# MEMO

**To:** Kristopher Byrd, Well Construction and Compliance Section Manager  
**From:** Travis Kelly, Well Construction Program Coordinator  
**Subject:** Review of Water Right Application G-19002  
**Date:** December 11, 2020

# Groundwater Application Review Summary Form

Application # G- 19002

**Well 3, MARI 2890**

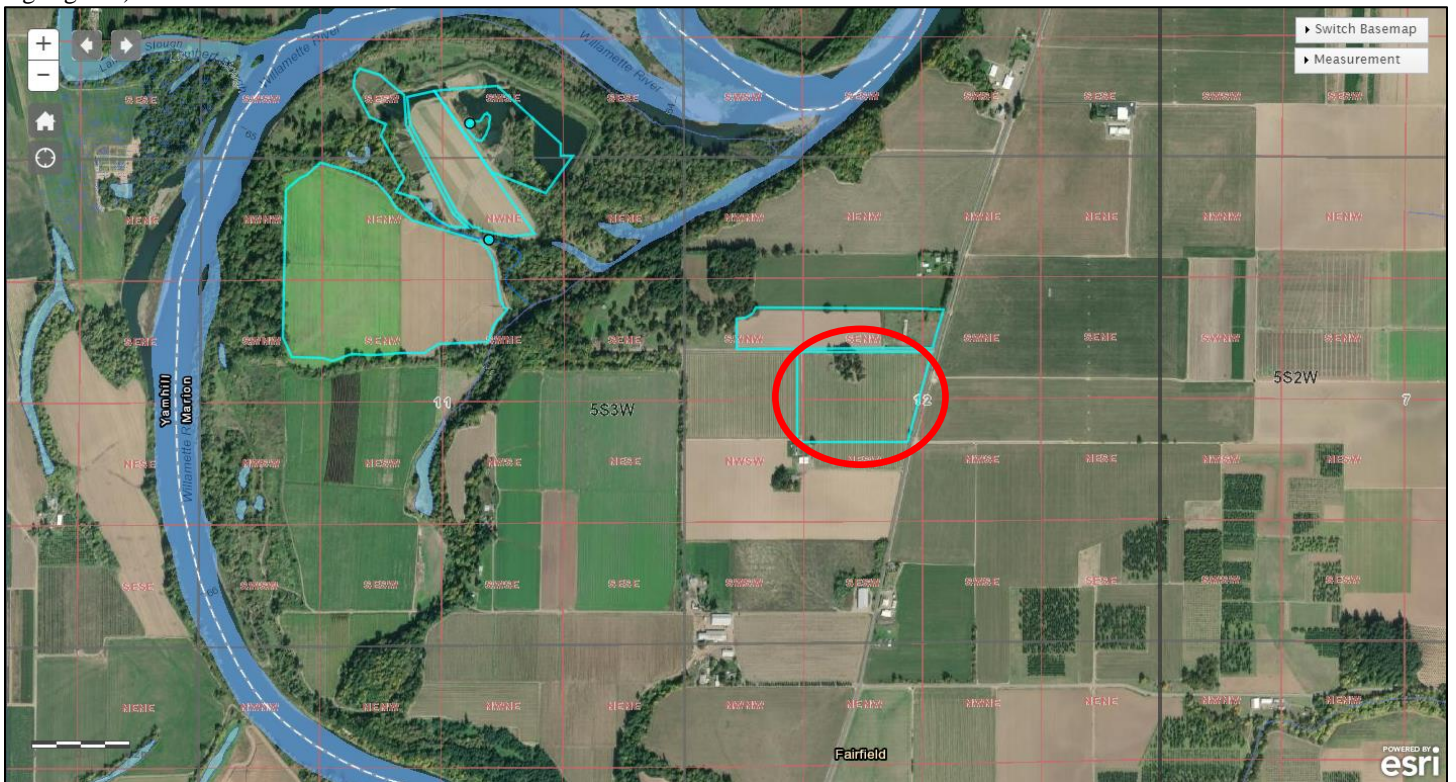
Well 3 (MARI 2890) is authorized for 2.16 cfs for irrigation of 172.6 acres under Permit G-11145 owned by Gerald A Baker. It appears that up to 30.2 acres irrigated under Permit G-11145 are proposed for irrigation from Well 3 under this application. This groundwater review evaluates against a stacked rate of 2.93 cfs. In November 2019, a pump test was rejected for this water right as it only measured the water level to the nearest foot. A new test has been submitted, although it has not yet been analyzed.
